Project
BARANGAROO SOUTH
R8

ISSUED FOR SECTION 75W
Title
GENERAL ARRANGEMENT PLAN
Level 1 Floor Plan

ISSUED FOR SECTION 75W

Title
**GENERAL ARRANGEMENT PLAN
Level 2 Floor Plan**

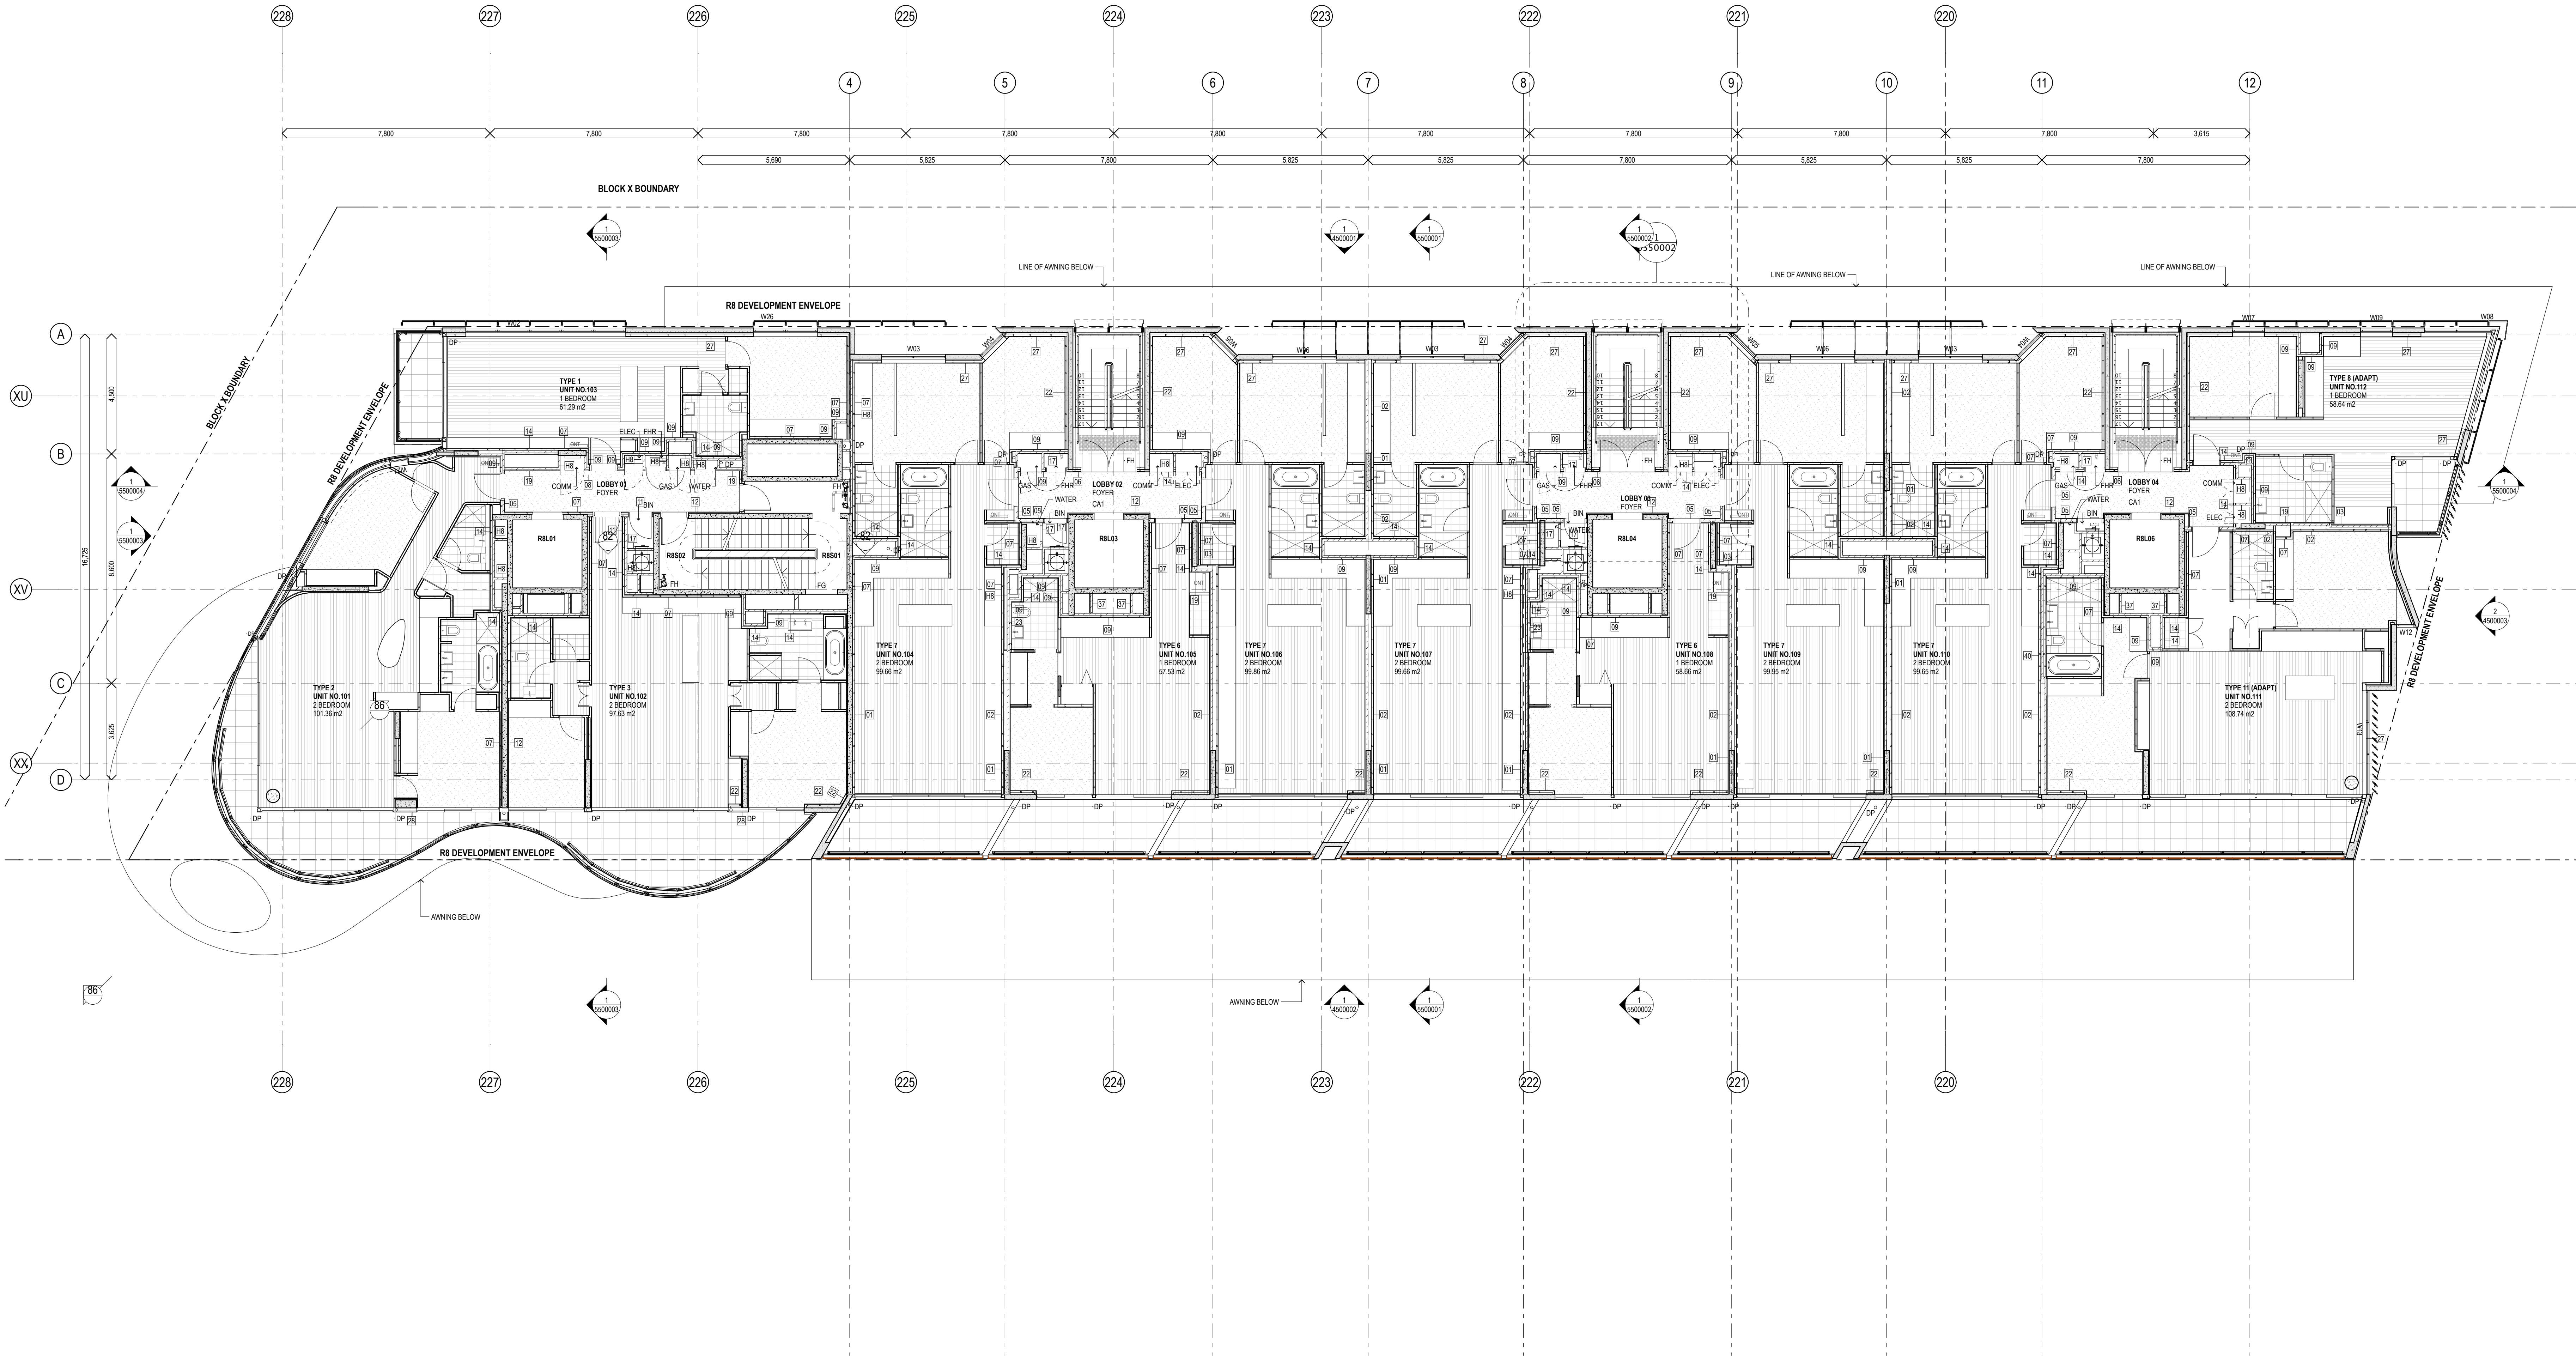
STW AMENDMENTS
A- SERVICE EXHAUST ENCLOSURES ADDED
B- WINDOW AND DOOR LOCATIONS TO EASTERN WALL SLIGHTLY ADJUSTED
C- EXTENT OF TERRACES SLIGHTLY ADJUSTED
D- INDICATIVE SHOPFRONTS, AWNINGS & RETAIL SIGNAGE - REFER TO BR8AD2000050
E- REVISED HEIGHT ALLOWANCE TO ROOF PV CELLS - RL+1.900

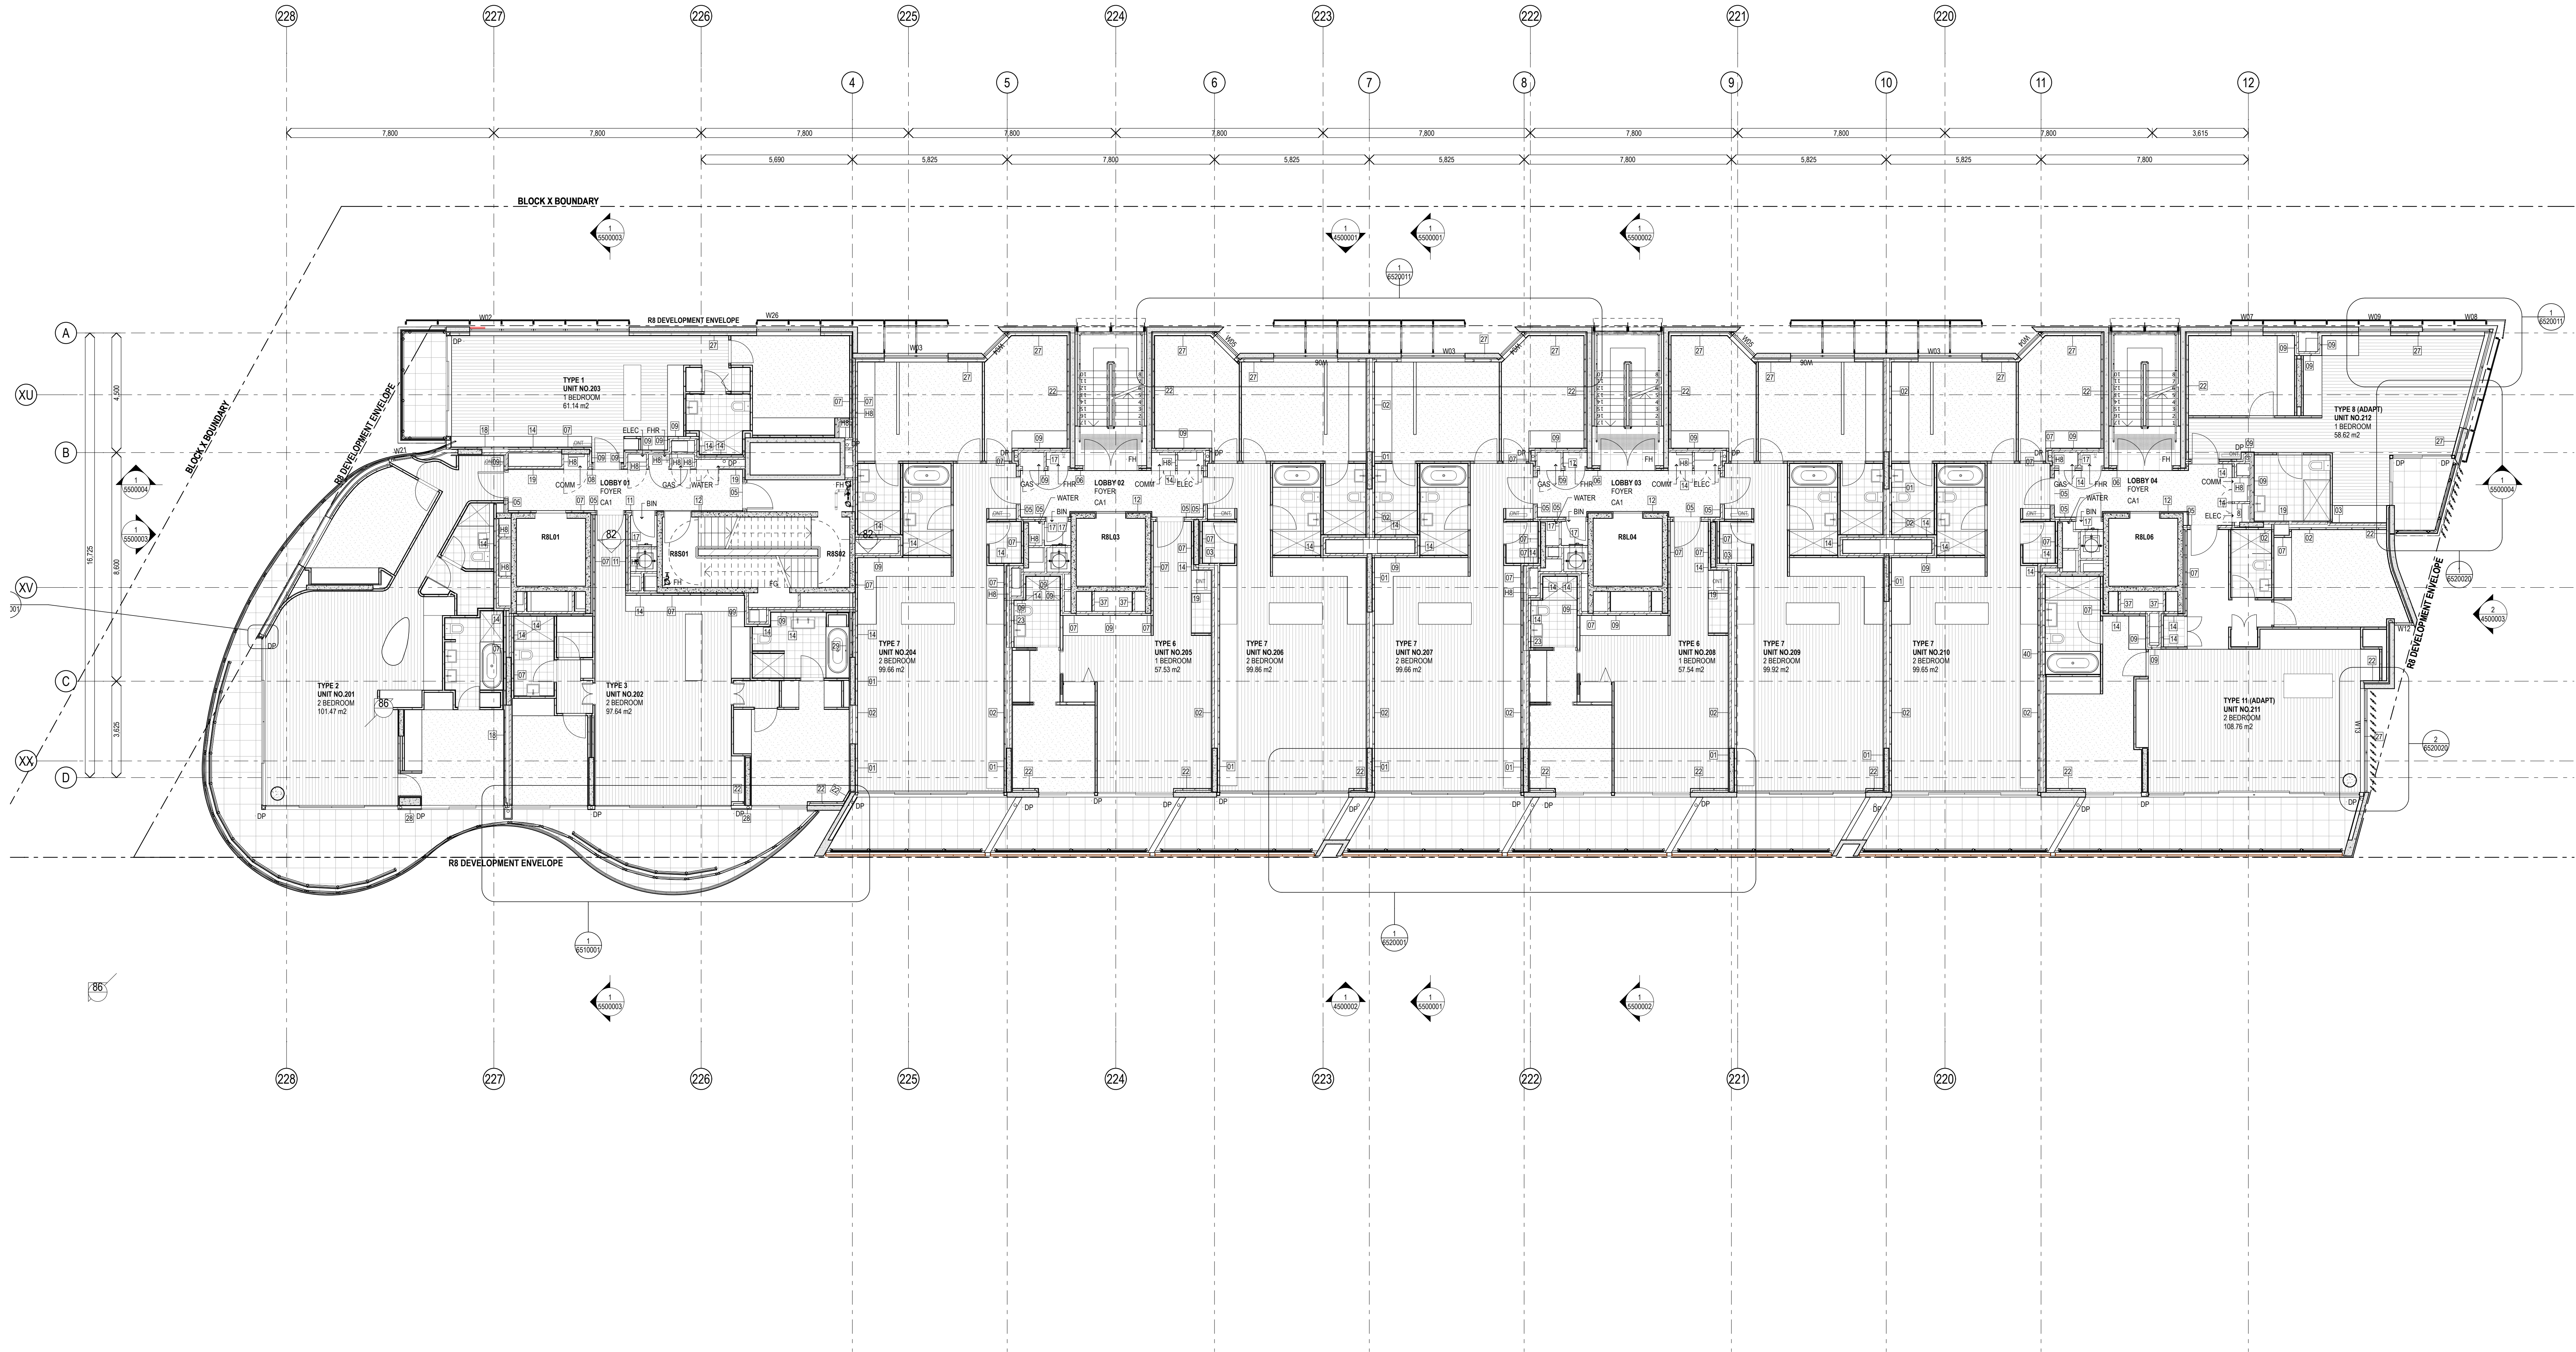
- A- SERVICE EXHAUST ENCLOSURES ADDED
- B- WINDOW AND DOOR LOCATIONS TO EASTERN WALL SLIGHTLY ADJUSTED
- C- EXTENT OF TERRACES SLIGHTLY ADJUSTED
- D- INDICATIVE SHOPFRONTS, AWNINGS & RETAIL SIGNAGE - REFER TO BR8AD2000050
- E- REVISED HEIGHT ALLOWANCE TO ROOF PV CELLS - RL+1.980

Level 3 Floor Plan

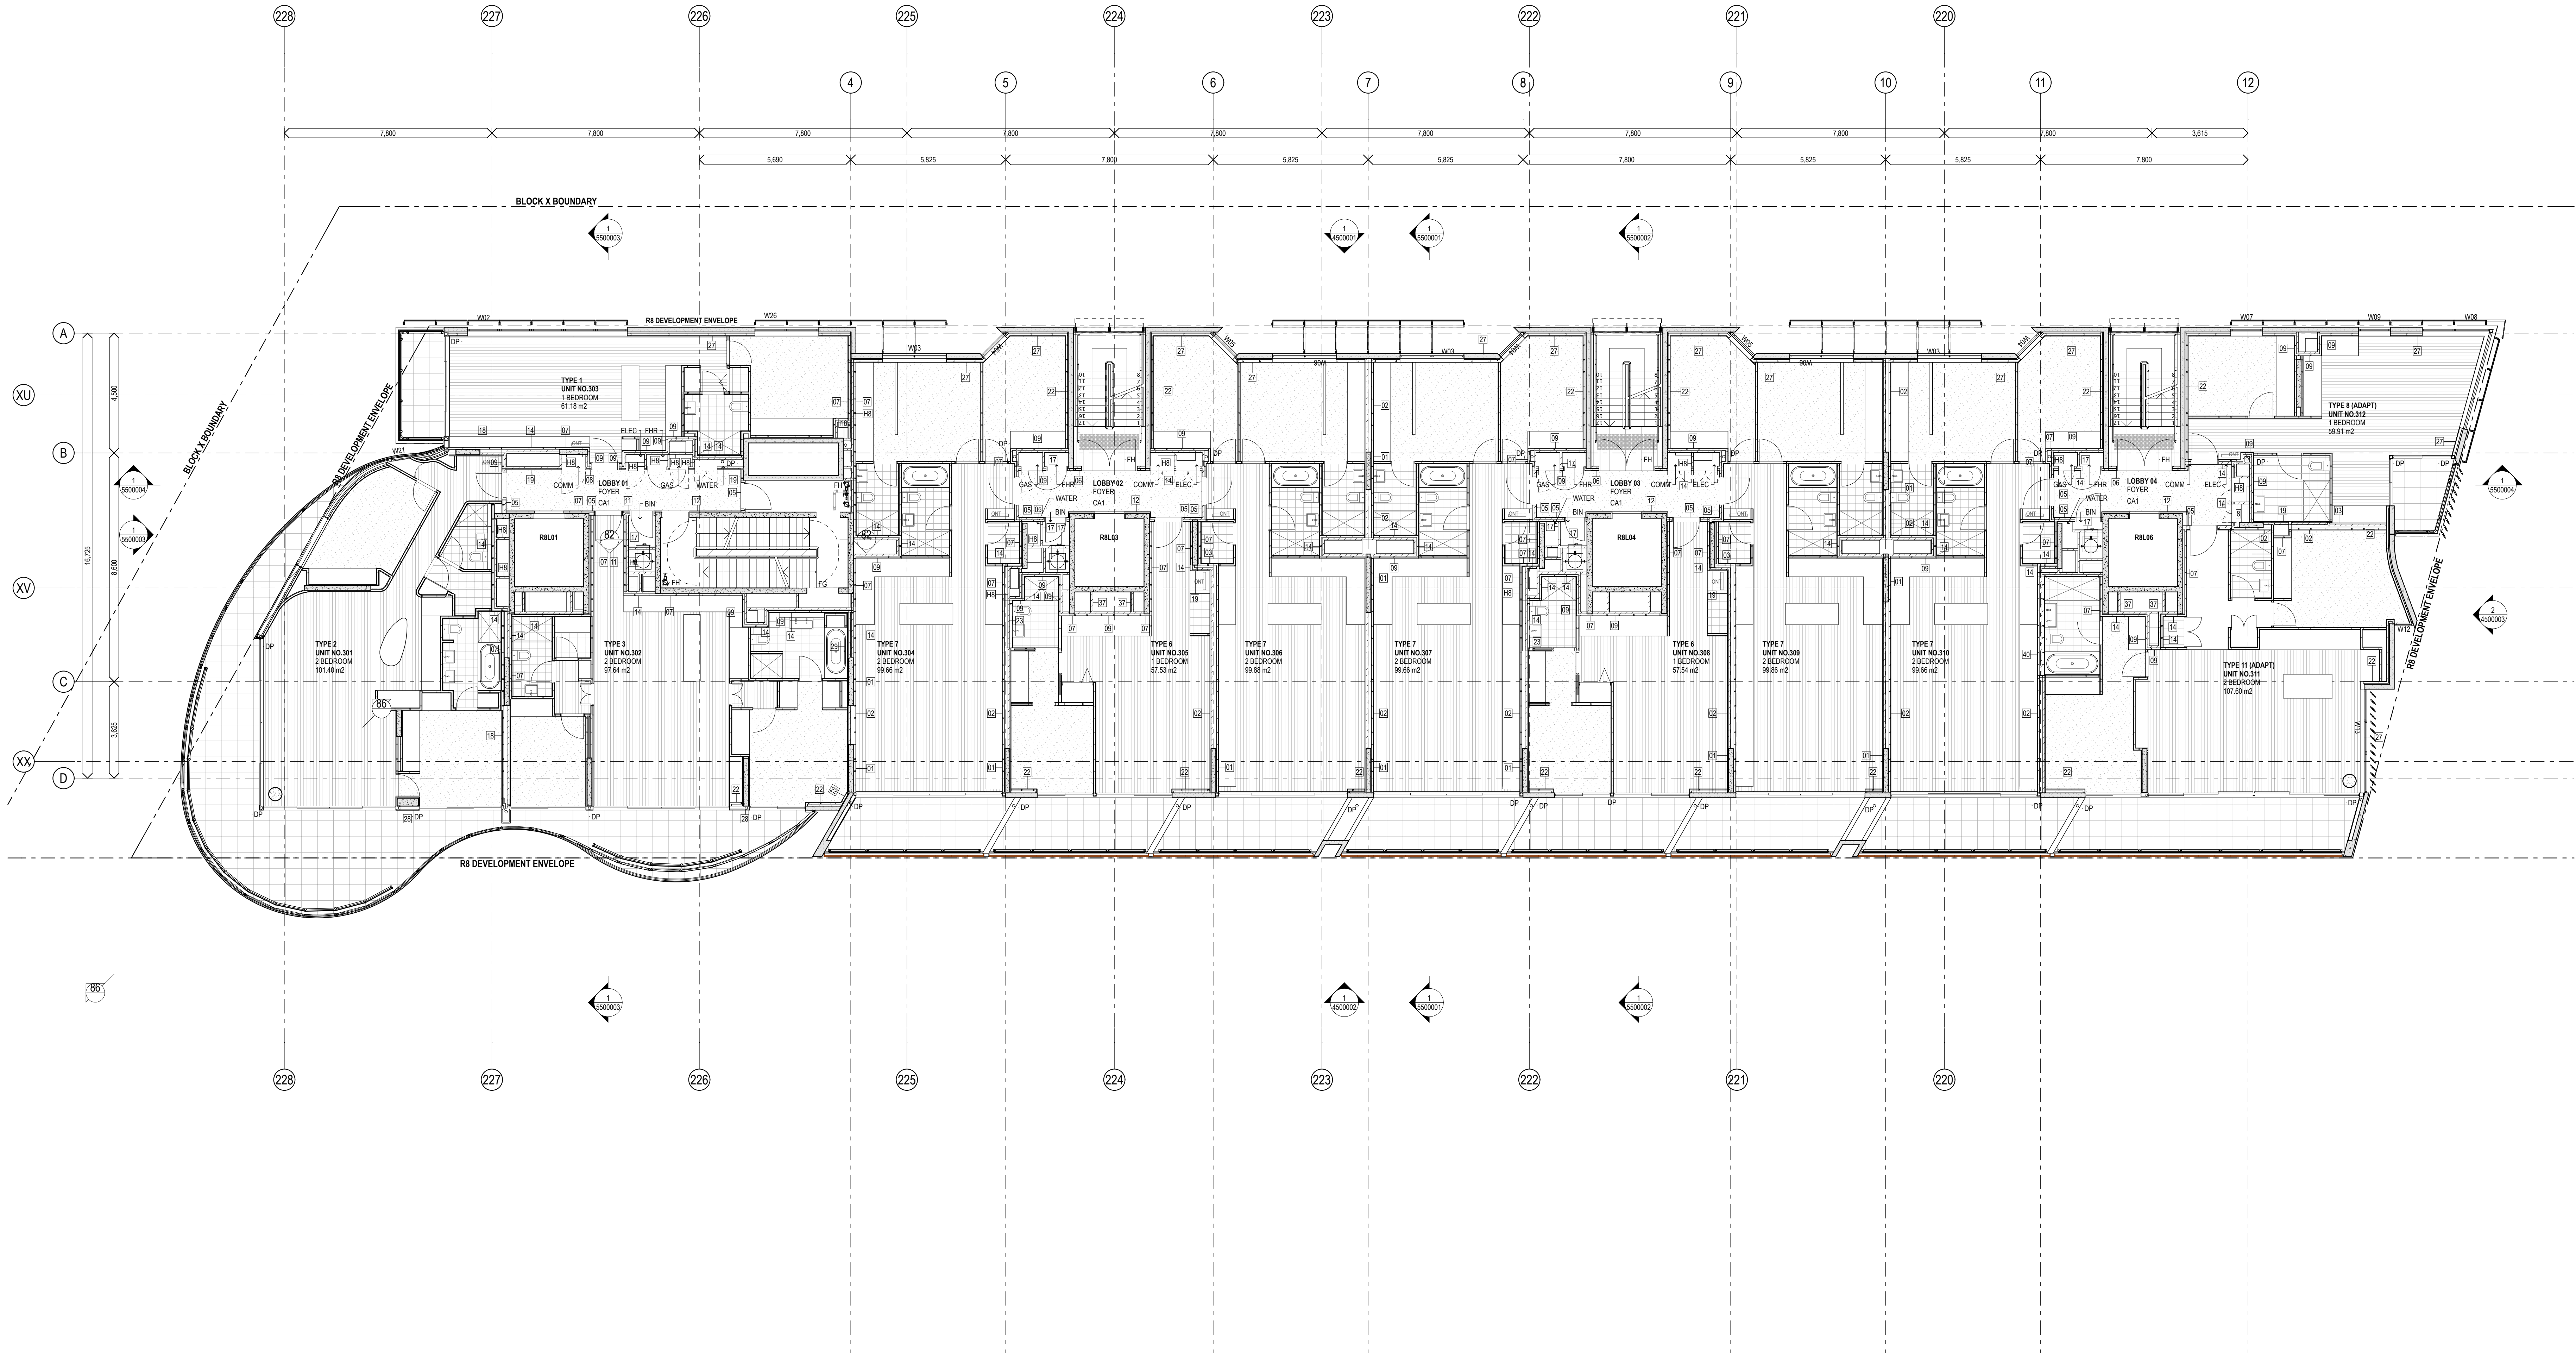
- A- SERVICE EXHAUST ENCLOSURES ADDED
- B- WINDOW AND DOOR LOCATIONS TO EASTERN WALL SLIGHTLY ADJUSTED
- C- EXTENT OF TERRACES SLIGHTLY ADJUSTED
- D- INDICATIVE SHOPFRONTS, AWNINGS & RETAIL SIGNAGE - REFER TO BR8AD3030000
- E- REVISED HEIGHT ALLOWANCE TO ROOF PV CELLS - RL+1.980
